FirstEnergy Nuclear Operating Company

November 30, 2006  
L-06-157

**Subject: Beaver Valley Power Station, Unit Nos. 1 and 2  
BV-1 Docket No. 50-334, License No. DPR-66  
BV-2 Docket No. 50-412, License No. NPF-73  
Supplemental Information – Steam Generator Tube Rupture (SGTR)  
Analysis Update**

### Changes to Previously Docketed Information Relative to EPU and the BVPS-2 SGTR Analysis

**Figure 5.4.2-1**  
**BVPS-2 Margin to Overfill Analysis**  
**Pressurizer Level**

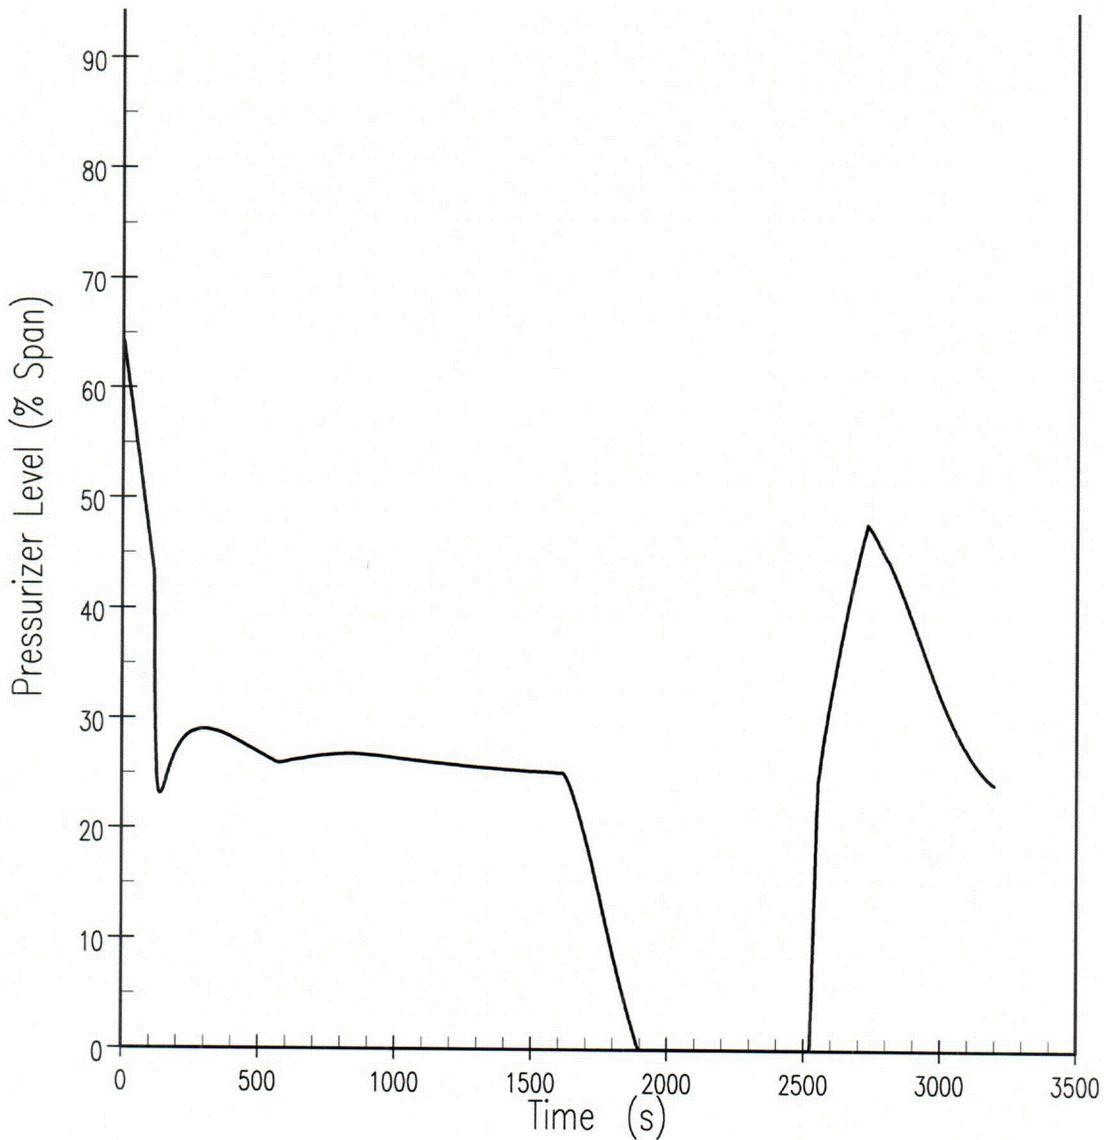
Following the tube rupture, reactor coolant flows from the primary into the secondary side of the ruptured steam generator since the primary pressure is greater than the steam generator pressure. In response to this loss of reactor coolant, pressurizer level decreases as shown in Figure 5.4.2-1. The RCS pressure also

After isolation of the ruptured steam generator, a 2.4-minute operator action time is imposed prior to initiating the cooldown with operation of the ASDVs from the MCR. With the failure of the 480 volt orange bus failure, the ASDVs must be operated locally. Additionally, the RHRV is opened after the gate valve upstream of the RHRV, which is connected to the ruptured steam generator, is closed locally. After this time, actions are taken to cool the RCS as rapidly as possible by dumping steam from the intact steam generators. Since offsite power is lost, the RCS is cooled by dumping steam to the atmosphere using the ASDVs on both intact steam generators and the RHRV. ~~This assumes a failure that results in the RHRV not being available for the cooldown.~~ It is assumed that the ASDVs and RHRV are opened at approximately 1612~~132~~ seconds for the RCS cooldown. The cooldown is continued until RCS subcooling at the ruptured steam generator pressure is 20°F plus an allowance of 21°F for subcooling uncertainty. When these conditions are satisfied at 2234~~020~~ seconds, it is assumed that the operator closes the ASDVs and RHRV to terminate the cooldown. This cooldown is performed so that there will be adequate subcooling in the RCS after the subsequent depressurization of the RCS to the ruptured steam generator pressure. The reduction in the intact steam generator pressure required to accomplish the cooldown is shown in Figure 5.4.2-3, and the effect of the cooldown on the RCS temperature is also shown in Figure 5.4.2-4. The pressurizer level and RCS pressure also decreases during this cooldown process due to shrinkage of the reactor coolant as shown in Figures 5.4.2-1 and 5.4.2-2.

The RCS depressurization is performed to establish adequate coolant inventory prior to terminating SI flow. A 4-minute operator action time is included prior to the RCS depressurization. With the RCPs stopped, normal pressurizer spray is not available and thus the RCS is depressurized by opening a pressurizer PORV. The RCS depressurization is initiated at 2476~~262~~ seconds and continues until any of the following conditions are satisfied: RCS pressure is less than the ruptured steam generator pressure and pressurizer level is greater than the allowance of 4% for pressurizer level uncertainty, or pressurizer level is greater than 75%, or RCS subcooling is less than the 21°F allowance for subcooling uncertainty. For this case, the RCS depressurization is terminated at 2552~~334~~ seconds because the RCS pressure is reduced to less than the ruptured steam generator pressure and the pressurizer level is above 4%. The RCS depressurization (Figure 5.4.2-2) reduces the break flow as shown in Figure 5.4.2-5 and increases SI flow to refill the pressurizer, as shown in Figure 5.4.2-1.

**Figure 5.4.2-2**  
**BVPS-2 Margin to Overfill Analysis**  
**RCS Pressure**

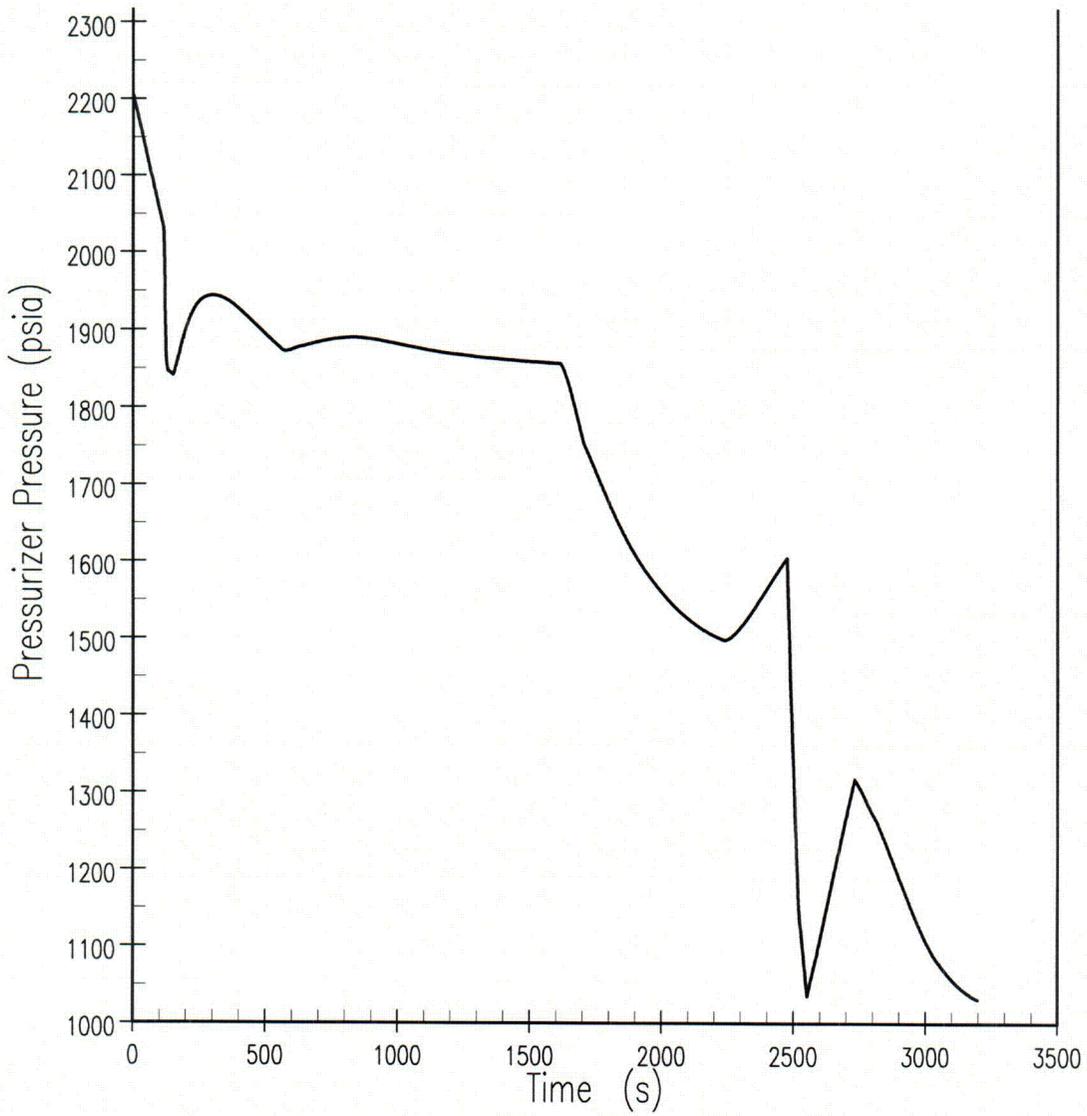
decreases as shown in Figure 5.4.2-2 as the steam bubble in the pressurizer expands. As the RCS pressure decreases due to the continued primary-to-secondary leakage, automatic reactor trip occurs on an overtemperature delta-T reactor trip signal at approximately 112 seconds.

After depressurization is completed, an operator action time of 3-minutes is assumed prior to SI termination. Since the above requirements are satisfied, SI termination actions are performed at ~~2732~~<sup>514</sup> seconds by closing off the SI flow path. After SI termination the RCS pressure begins to decrease as shown in Figure 5.4.2-2.

**Figure 5.4.2-5**  
**BVPS-2 Margin to Overfill Analysis**  
**Primary-to-Secondary Break Flow**

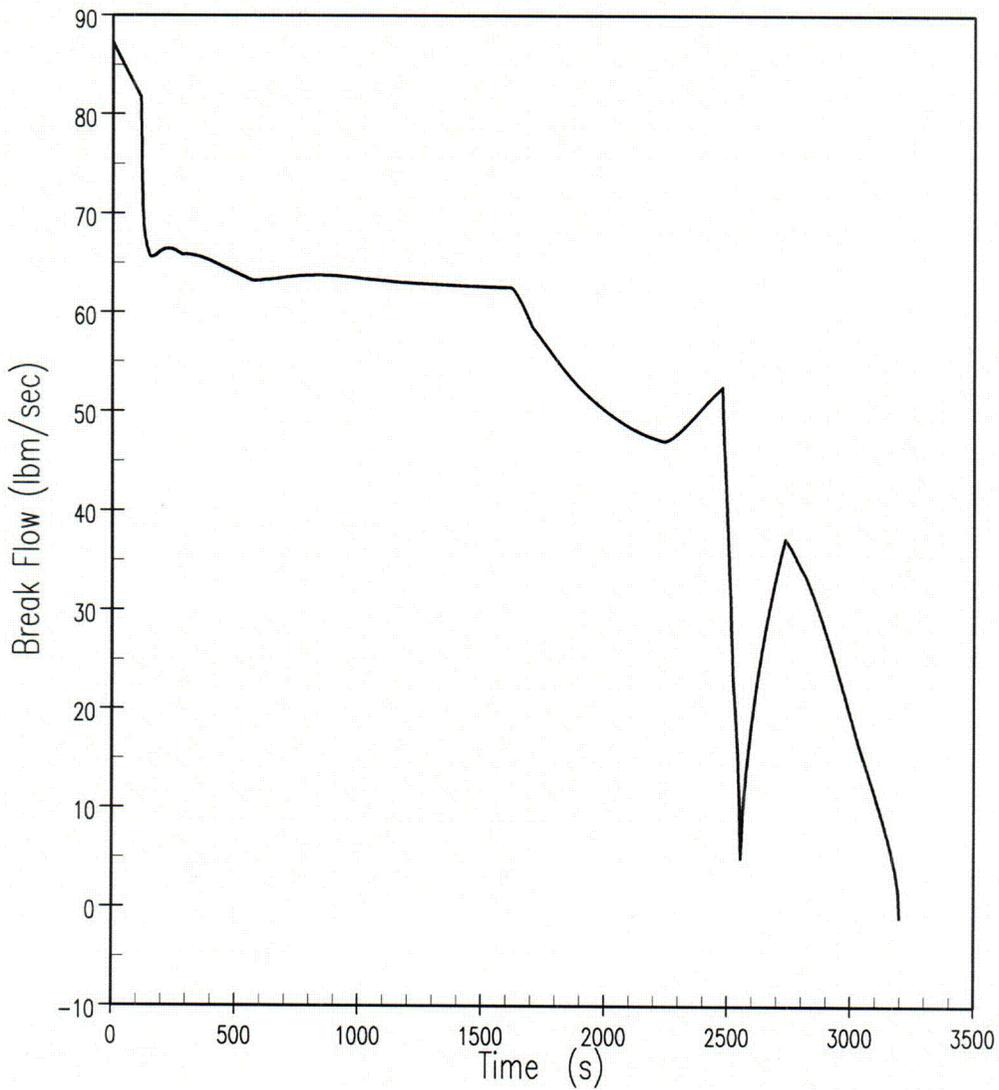
The primary-to-secondary break flow rate throughout the recovery operations is presented in Figure 5.4.2-5. The water volume in the ruptured steam generator is presented as a function of time in Figure 5.4.2-6. The secondary side volume of a single BVPS-2 steam generator, up to the outlet nozzle, is 5730 ft<sup>3</sup>. The peak ruptured steam generator water volume of ~~6023~~<sup>5656</sup> ft<sup>3</sup> is indicated in Figure 5.4.2-6 showing that there is ~~2174~~ ft<sup>3</sup> of margin to overfill ~~and 388 ft<sup>3</sup> of additional margin to MSSV flooding.~~ ~~(The orange bus power supply failure case resulted in an additional 5 ft<sup>3</sup> of margin, compared to the purple bus power supply failure.)~~ Therefore, it is concluded that steam generator overfill will not occur for a design basis SGTR for BVPS-2 at the NSSS power of 2910 MWt, ~~and additional margin exists considering the water volume available prior to MSSV flooding.~~
